2641 4th Street

Site Review Written Statement

Project Address: 2641 4th Street
Project Owner: Moonbeam Boulder, LLC
Current Zoning: Currently under city-initiated rezoning to RL-1

EXHIBIT G: PROPOSED PHASING PLAN
2641 4th Street
June 4, 2012

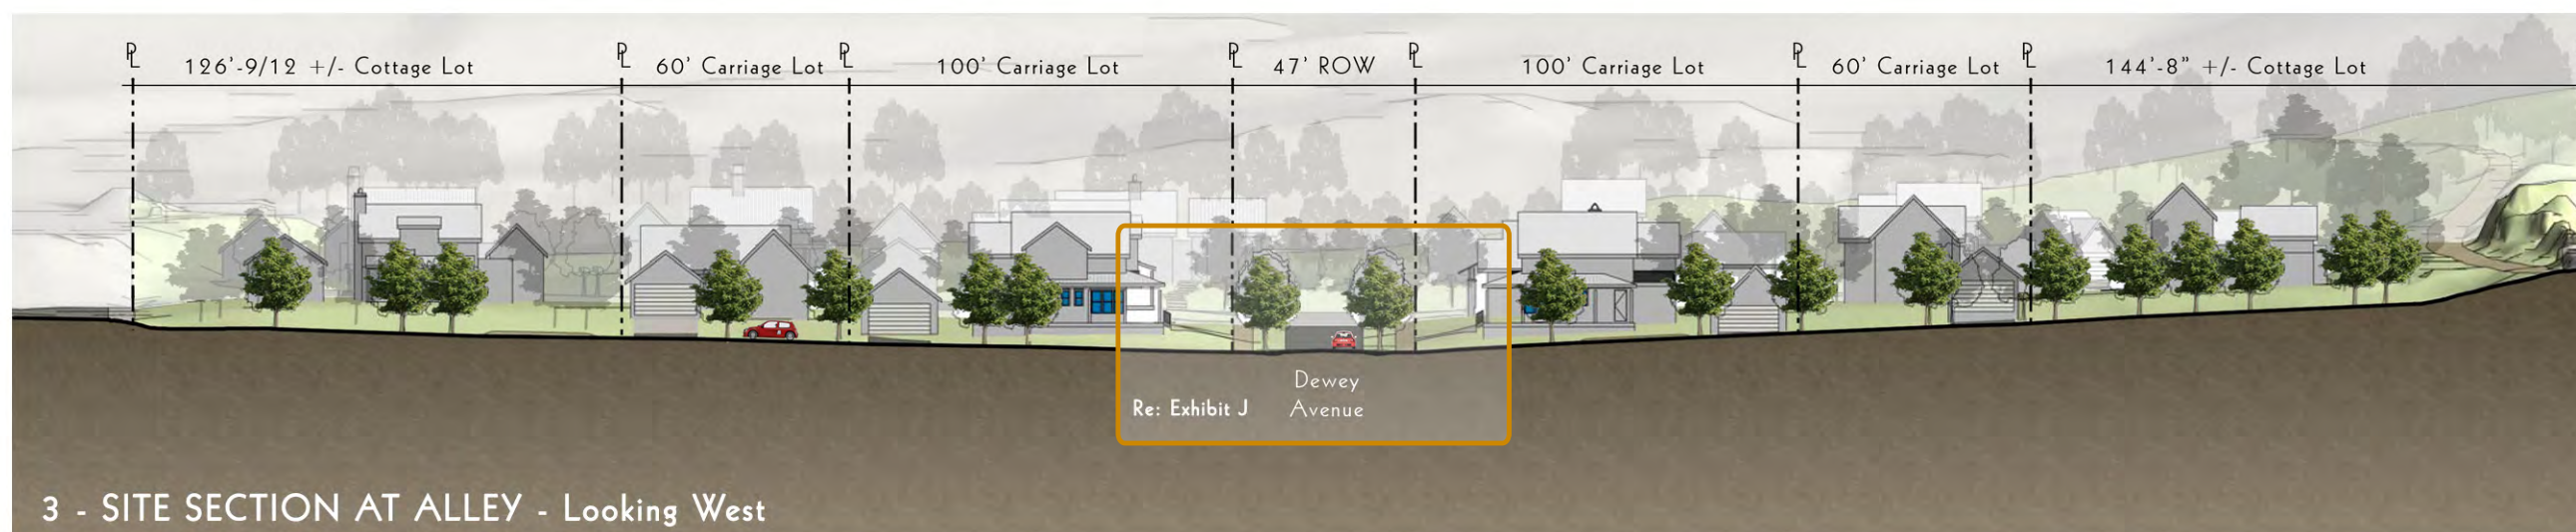
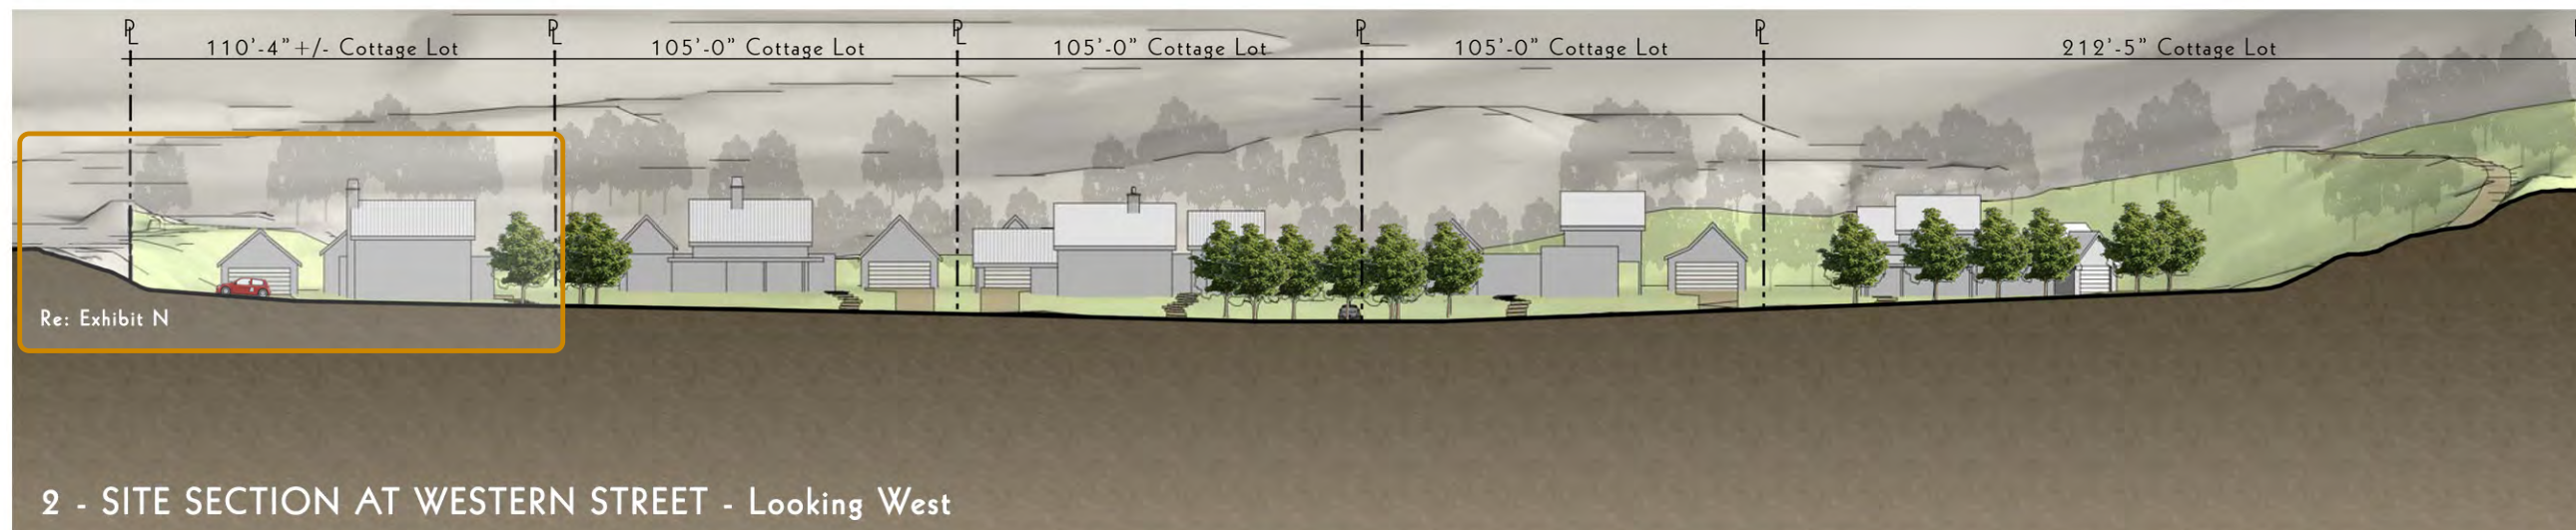
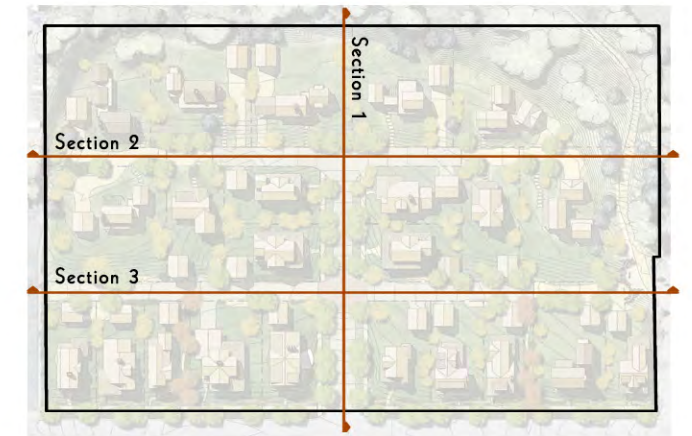
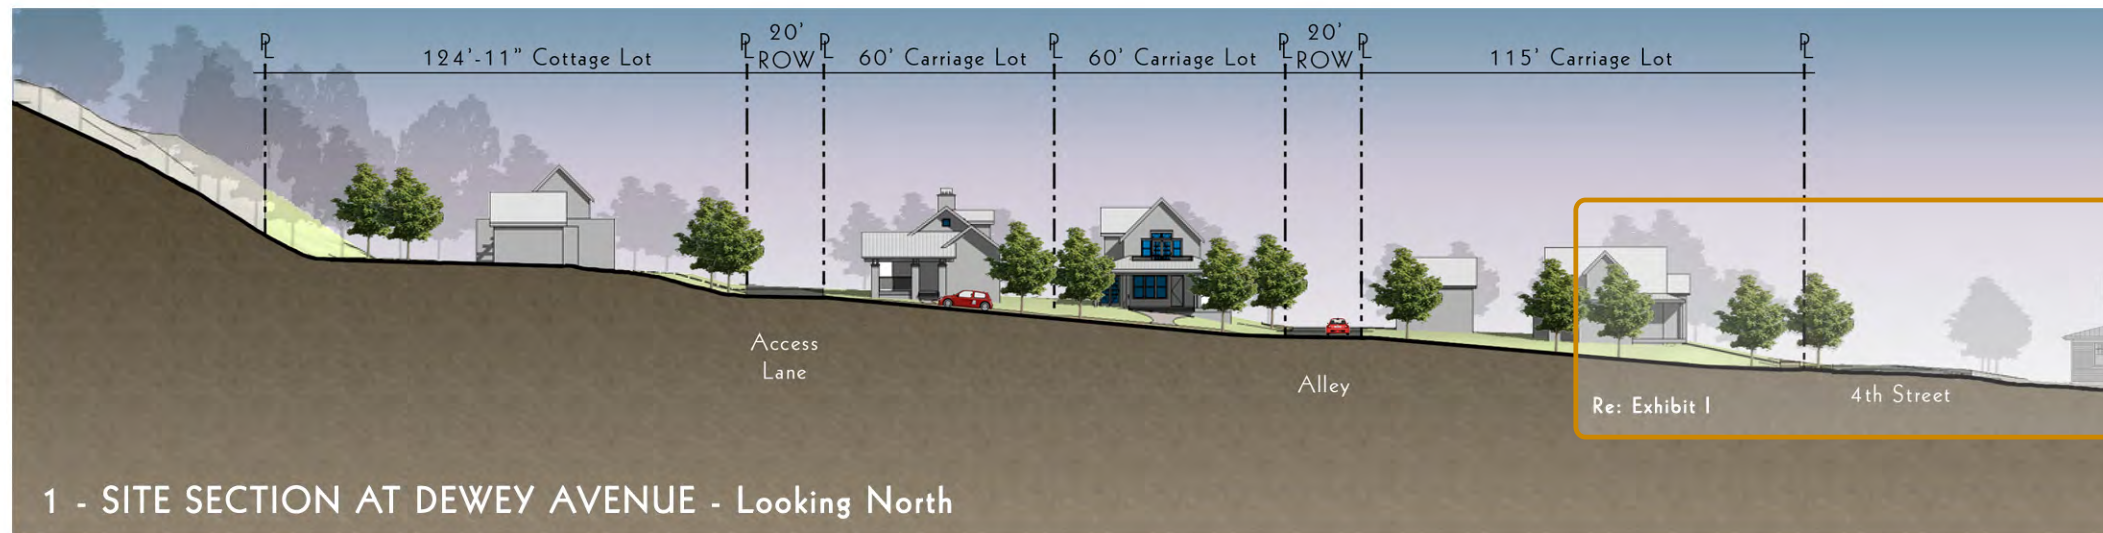
- **A detailed construction phasing plan, to be discussed at Site Review;**

A phasing plan is included in the attached exhibits.
